FORM APPROVED
OMB No. 1004-0137
Expires: October 31, 2014SUNDRY NOTICES AND REPORTS ON WELLS
Do not use this form for proposals to drill or to re-enter an abandoned well. Use Form 3160-3 (APD) for such proposals.

7. If Unit of CA/Agreement, Name and/or No.
Federal8. Well Name and No.
19. API Well No.
30-025-2630410. Field and Pool or Exploratory Area
EUNICE SAN ANDRES, SOUTHWEST11. County or Parish, State
LEA NEW MEXICO

**Federal 1
30-025-26304
Vanguard Permian LLC
February 05, 2016
Conditions of Approval**

Federal 1
Yates, Queen/Penrose Skelly - 30-025-26304
Lea County, New Mexico
PROPOSED COMPLETION - 8/2014

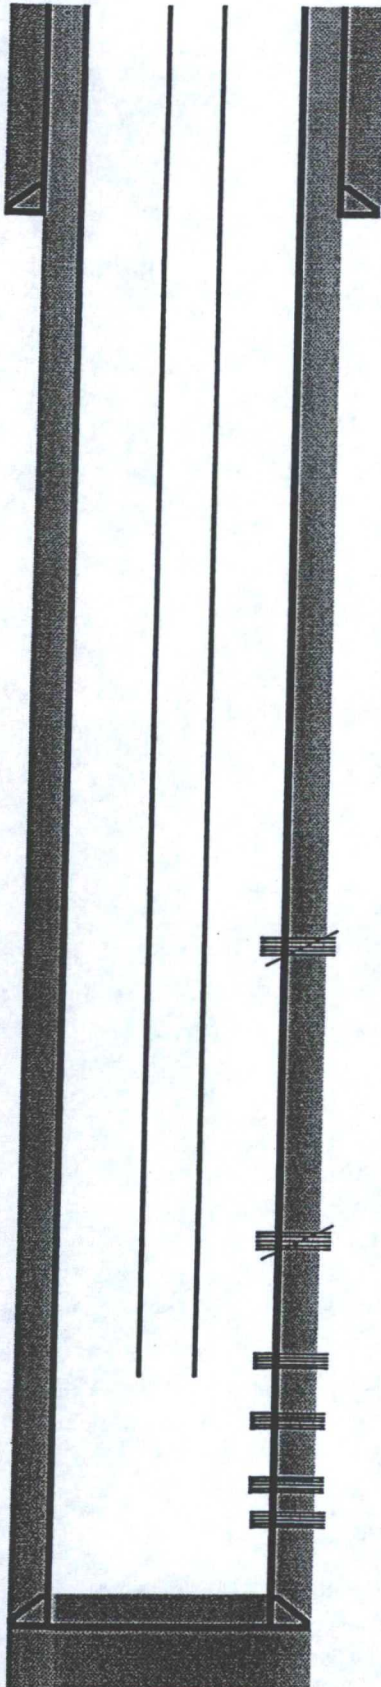
- 1. Cement squeeze approved as written.**
- 2. Must conduct a casing integrity test before perforating and fracturing. Submit results to BLM. The CIT is to be performed on the production casing to max treating pressure. Notify BLM if test fails**
